TO: Mercedes-Benz Dealer Principals, General Managers, Sales Managers, Service Managers, Parts Managers	FROM: Gregory Gunther, Department Manager, Vehicle Compliance and Analysis, Engineering Services
RE: Service Campaign Launch Notification MY18-19 E, GLC-Class (213, 253 platform) Retrofit Protective Grille	DATE: May 10, 2019

Campaign No. 2019040010, May 2019

SUBJECT: **Model E-Class and GLC-Class (213, 253 platform)**
Model Year 2018-2019

Retrofit protective grille for additional cooler

Figure 1

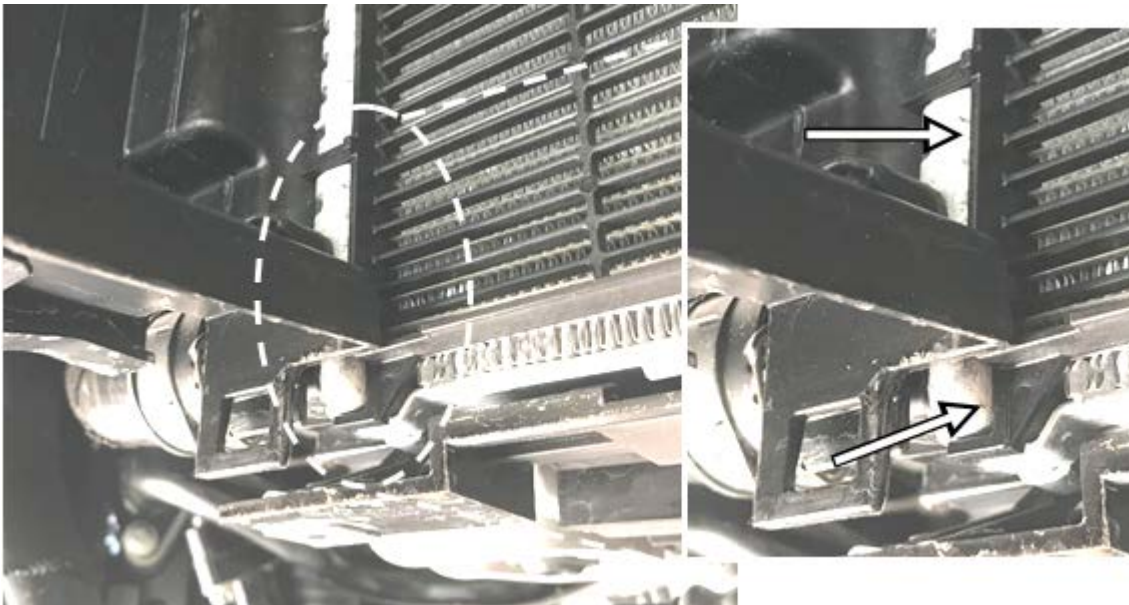
1. Remove front section of engine compartment lining.
 - i** For basic data of model 213, see **AR61.20-P-1105LWE**
 - i** For basic data of model 253, see **AR61.20-P-1105LW**
2. Unclip additional cooler with connected lines and detach downwards.
 - i** Coolant **must not** be drained.
 - i** Coolant lines **must not be** disconnected.
 - i** For basic data of model 213, see **AR20.20-P-3867MNE**
 - i** For basic data of model 253, see **AR20.20-P-3867MNG**
3. Insert protective grille from underneath (**figure 1**) and attach on left and right at corners (**figure 2**) of additional cooler.
 - i** Protective grille is mounted flush with the cooler edge.
